**Service Bulletins
January 1979 to
September 1986 inclusive**

**Rolls-Royce Silver Shadow
Long Wheelbase,
Corniche and Camargue
Bentley T Series and Corniche
Rolls-Royce Silver Shadow II
and Silver Wraith II
Bentley T2**

ALL ROLLS-ROYCE FRANCHISE HOLDERS
SERVICE BULLETIN INDEX FOR TSD 4318

Fig. 1 Valve spring compressor

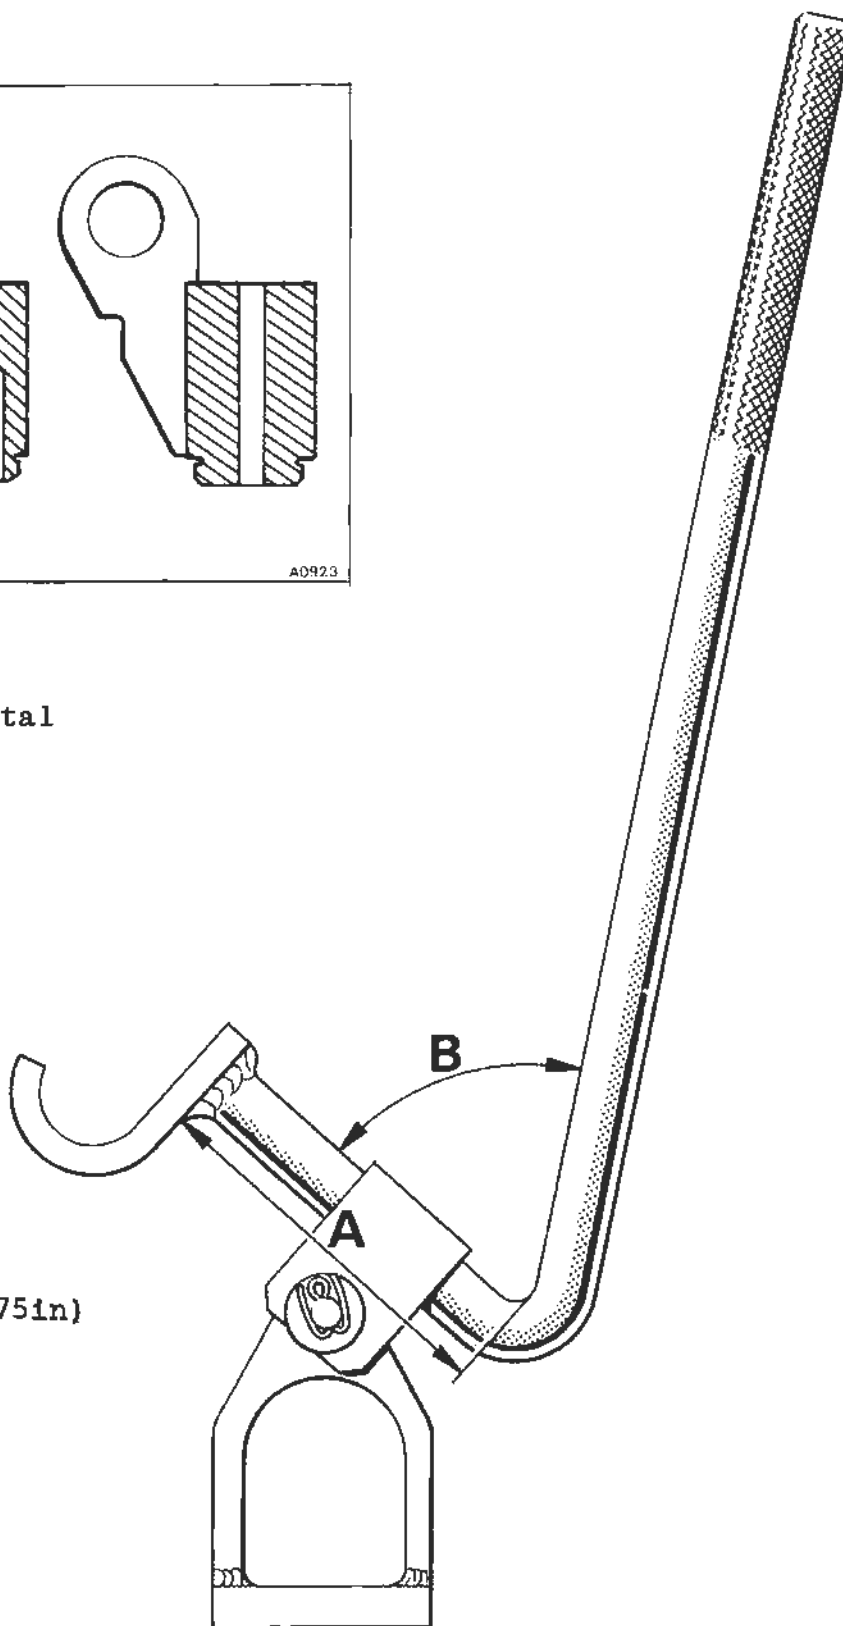
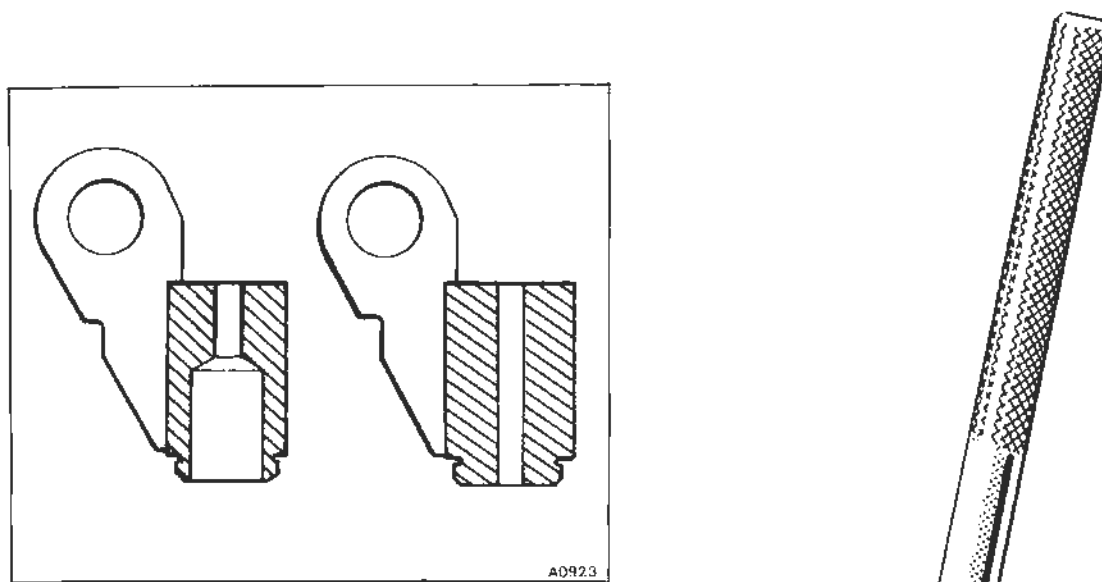
The modifications to the compressor comprise of a re-shaped operating lever and a revised pair of fulcrum bar pedestals which feature a recess to accomodate the cylinder head nut (see figs. 1 and 2).

To enable franchise holders to update their existing valve spring compressor, sets of the revised pedestals will be available separately, the existing operating lever should be modified as shown (see fig. 1).

Fig.1

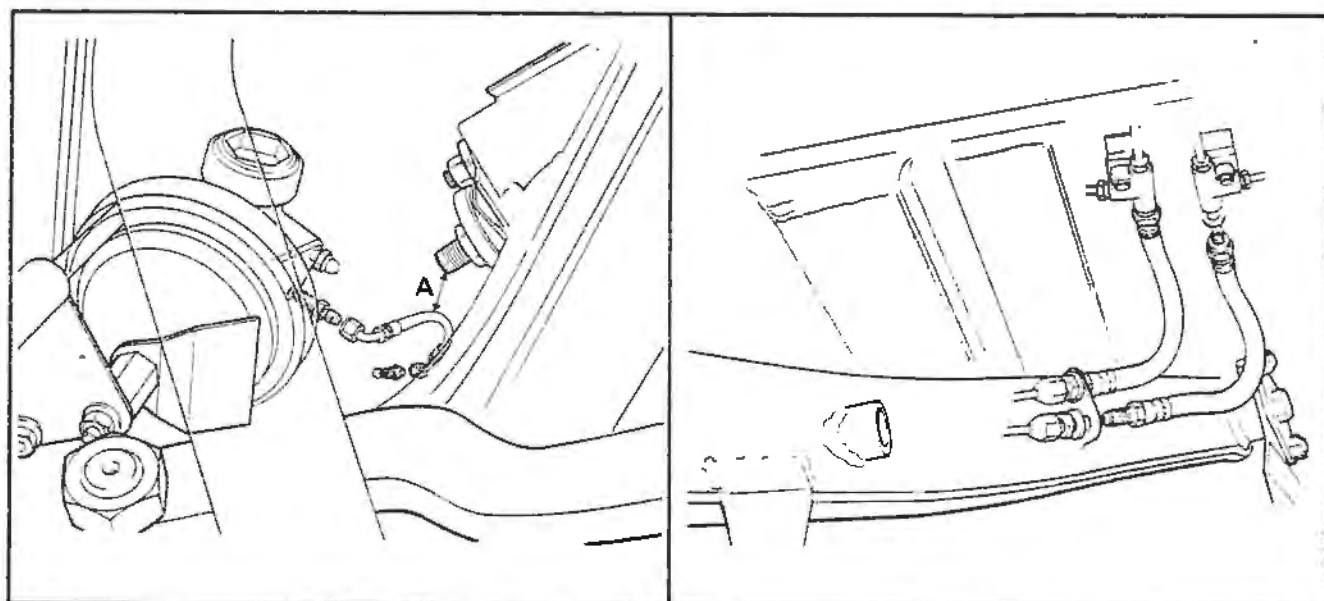
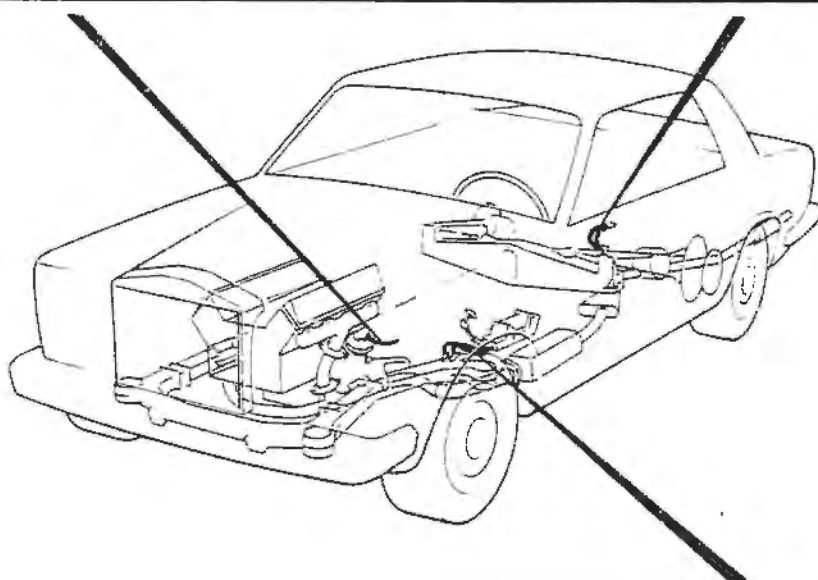
7. Remove the two hydraulic hoses from the left-hand trailing arm and fit the replacement hoses from the kit of parts. (see figs. 1b, 2a and 3b). Identification of hoses can be made by measuring their lengths and comparing them with the dimensions given in figure 4. Ensure that, where necessary, the copper washers are replaced with ones from the kit of parts.
8. Having replaced the hoses, refit the rear section of the exhaust system as detailed in Chapter Q of the Workshop Manual.

9. Remove the two hoses from the brake actuation mechanism to the front sub-frame, noting their connections on the sub-frame and their corresponding connections from the body. (see figs. 1c, 2d and 3c). As previously mentioned the hexagon sizes of the hoses have been increased from 9/16 in. A/F to 5/8 in. A/F on the replacement hoses. Because of this increase, it will be found that the corners of the hexagons foul when attempting to screw the hoses into the

FIG 6.

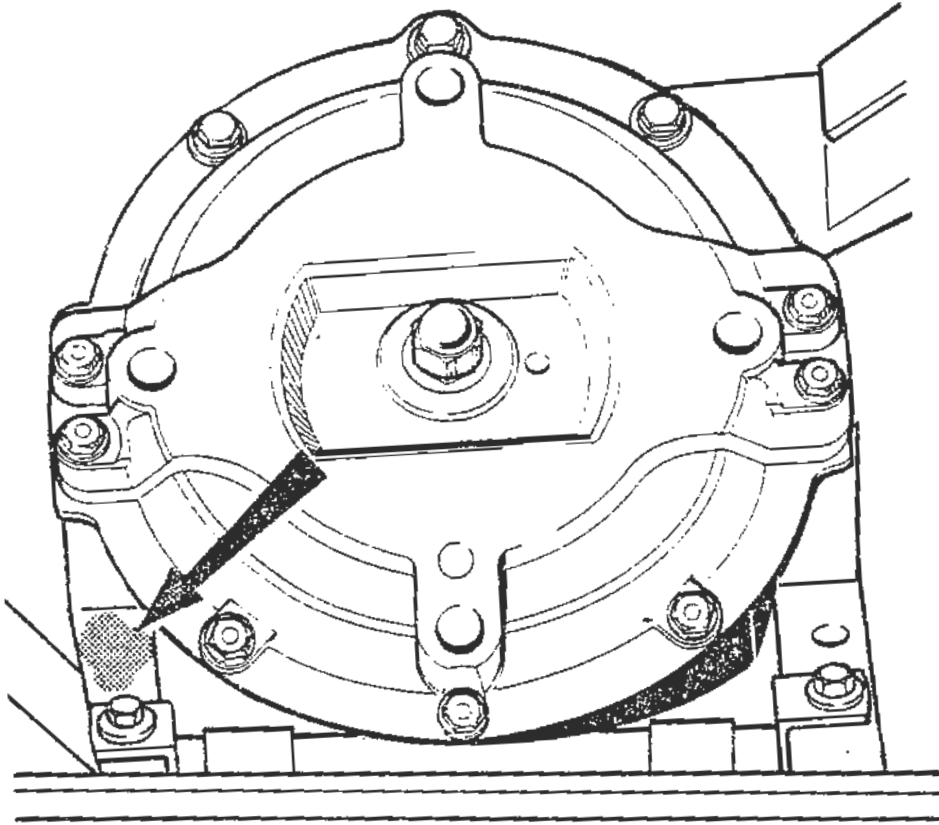
10. Having replaced all the hoses and fitted the heat shield, bleed the hydraulic system as detailed in Chapter G of the Workshop Manual.
11. On completion, the car itself should be identified for future reference by painting a white spot on the forward bracket adjacent to the left-hand spring pot as shown in figure 6.

FIG. 1

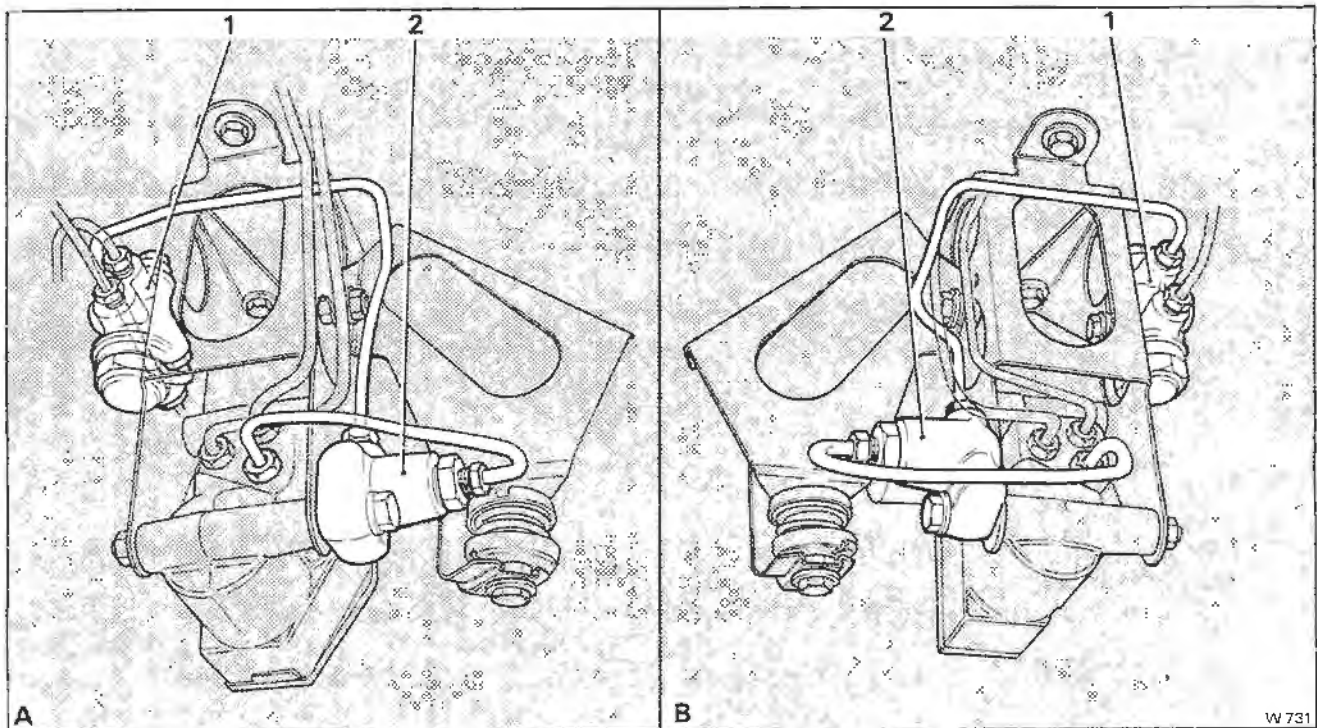
Restrictors have been incorporated into the hydraulic lines between the height control valves (HCVs) and minimum pressure valves (MPVs), see figure 1.

Fig. 1 Modified end support bracket

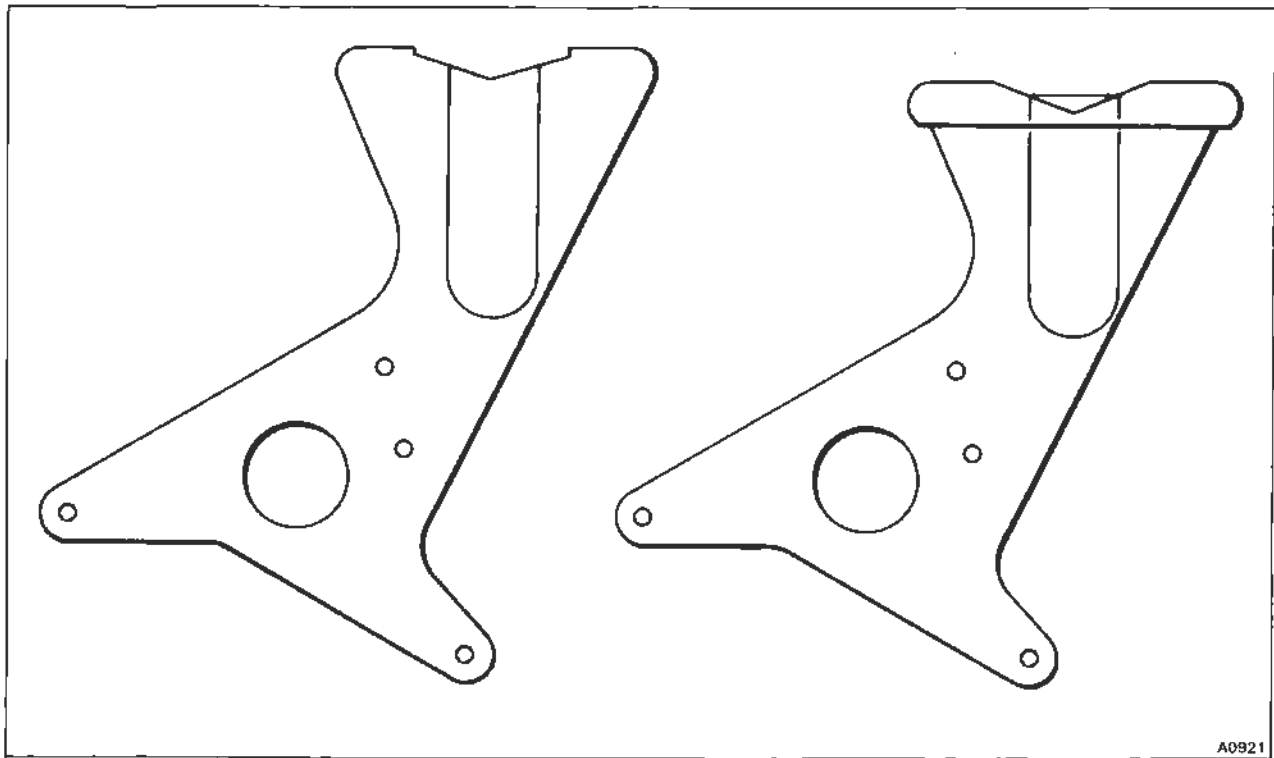
The modifications comprise of a shorter end support bracket and a shorter spacer for the front attachment point to the left-hand spring cover (see figs. 1 and 2).

Fig. 1

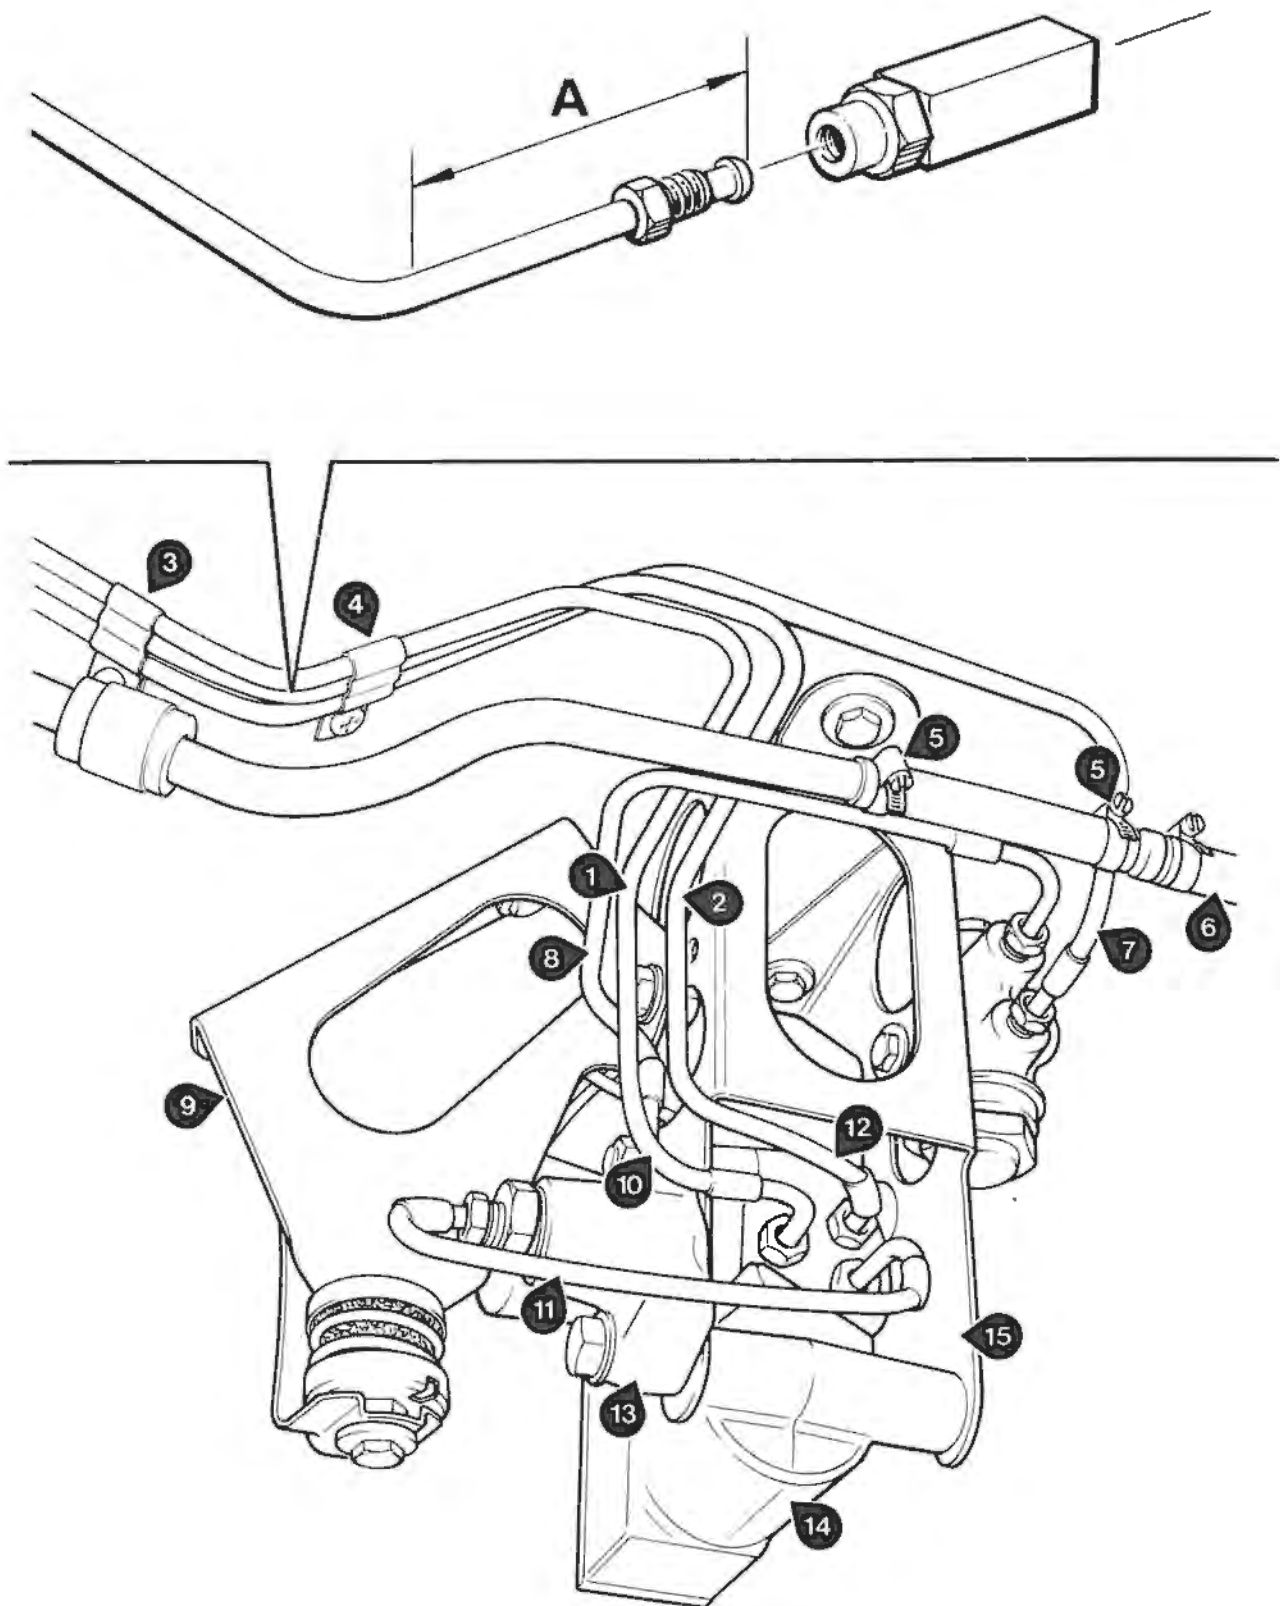
- 6 Remove the height control valve mounting bracket.
- 7 Clamp the hose in the fuel return line, on the fuel tank side of the non-return valve (see fig. 1, item 6). (Cars other than Turbo and petrol injection models).

- 8 Slacken the clips (see fig. 1, item 5) and remove the hose from the non-return valve.
- 9 Remove the clips securing the hydraulic pipes to the underfloor of the car (see fig. 1, items 3 and 4).

- 12 On earlier cars without filters, cut and flare the priority valve to height control pipe (see fig. 1, item 12) at the position marked A in figure 1 i.e. 44mm (1.75 in) from the bend. The filter can then be fitted in the position indicated.
- 13 Lower the height control valve to reservoir return pipe (see fig. 1, item 10). Cut the pipe (see fig. 1, item 1), fit a unified pipe union and reflare the pipe.
- 14 If the car is already fitted with hydraulic filters adjacent to the height control valve, it will be necessary to locally produce two pipes to connect the filters to the height control valves (see fig. 2).
- 15 Fit the shorter height control valve links to the new height control valves.
- 16 Fit the height control valve assemblies to the car, using the bolts supplied in the kit which accomodates the additional spacers, fitted between the mounting bracket and floor of the car.

Fig. 1 Flexible Spring Seat

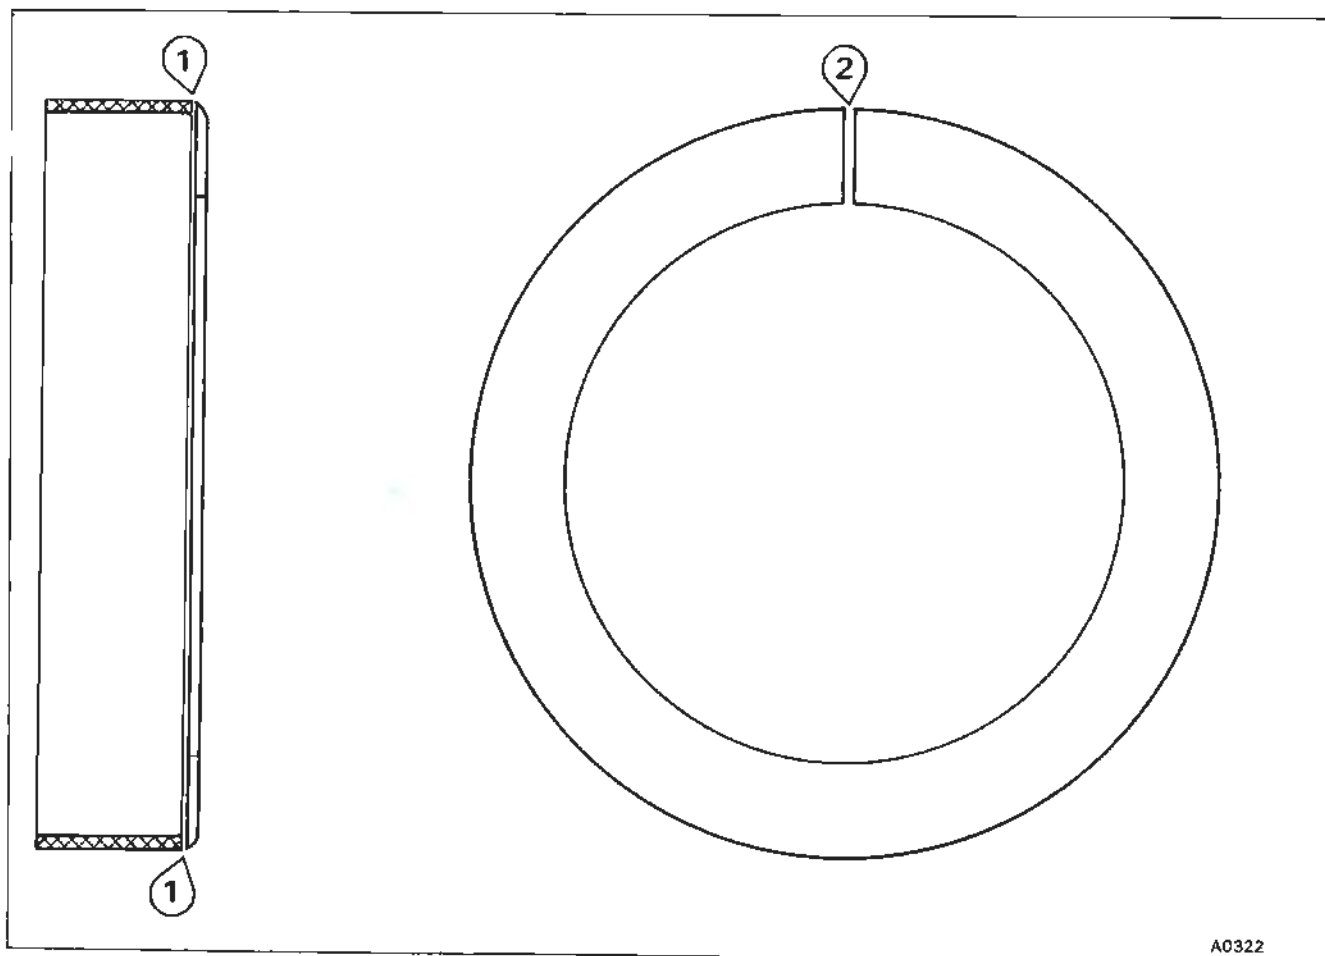
- 1 Remove the rear road spring as described in the relevant Workshop Manual.
- 2 Decompress the spring using service tool numbers RH 7909 and RH 9504.
- 3 Obtain four flexible rear road spring seats (part number UR 20847) remove the rim, then cut the remaining flat circular washer as illustrated in figure 1, items 1 and 2.
